SERVICE BULLETIN # 00168

SUBJECT: Installation of Latch Strike Spacer

MODELS: All Venders

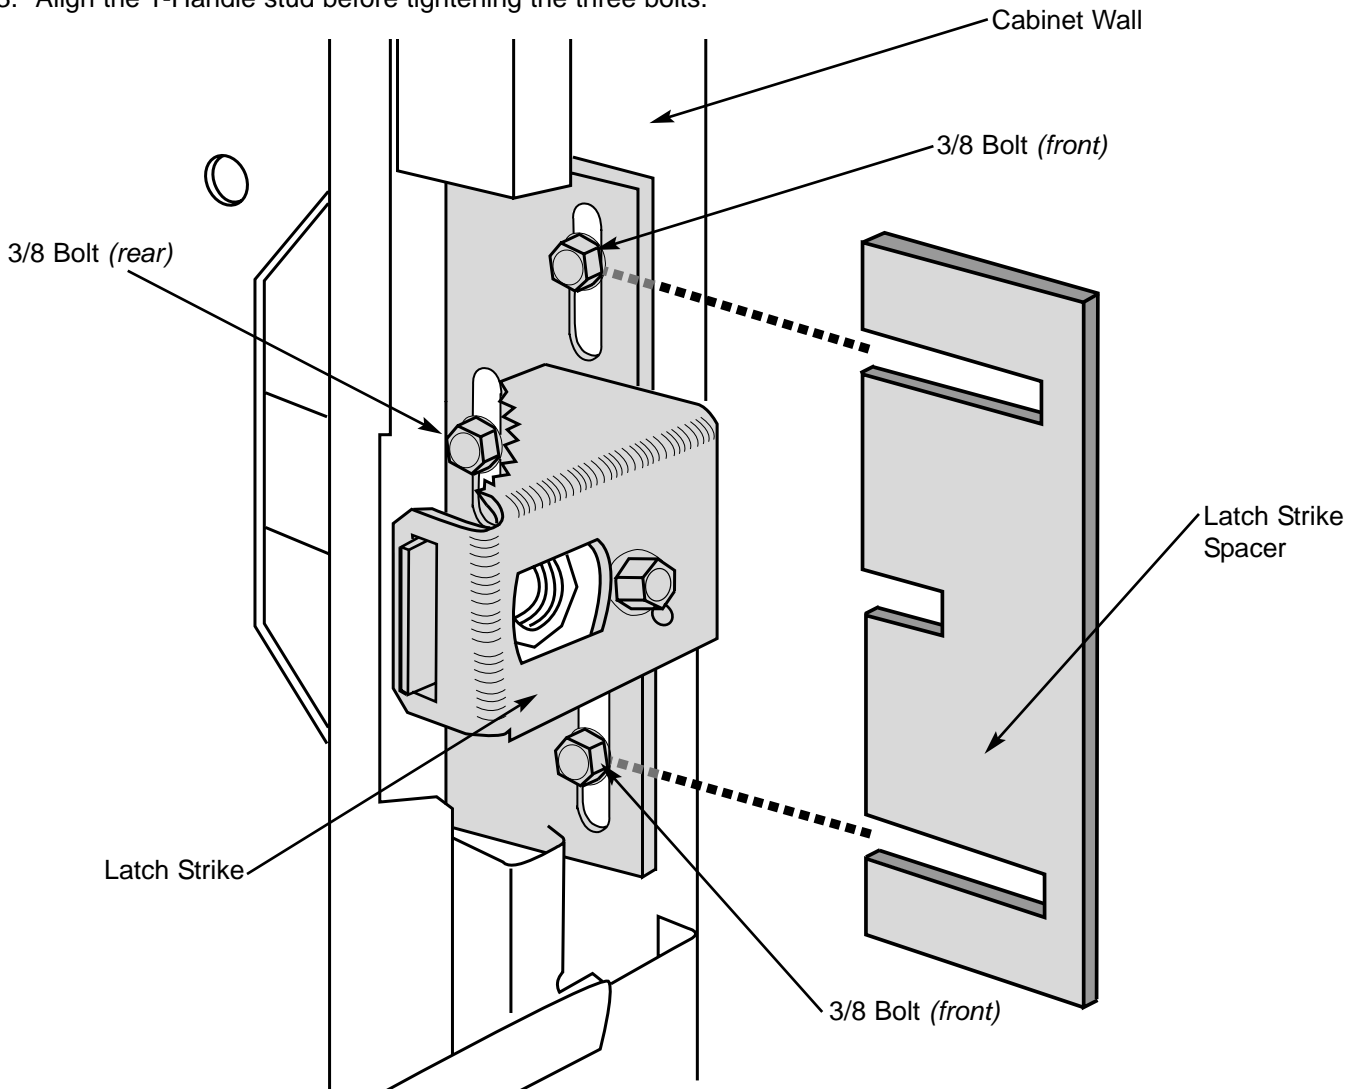
Reason for Fix:

T-Handle Stud not aligning up properly with the latch strike.

1. Loosen all three 3/8 bolts that secure the latch strike to the cabinet.
2. Insert the latch strike spacer between the cabinet wall and the latch strike.
3. Align the T-Handle stud before tightening the three bolts.
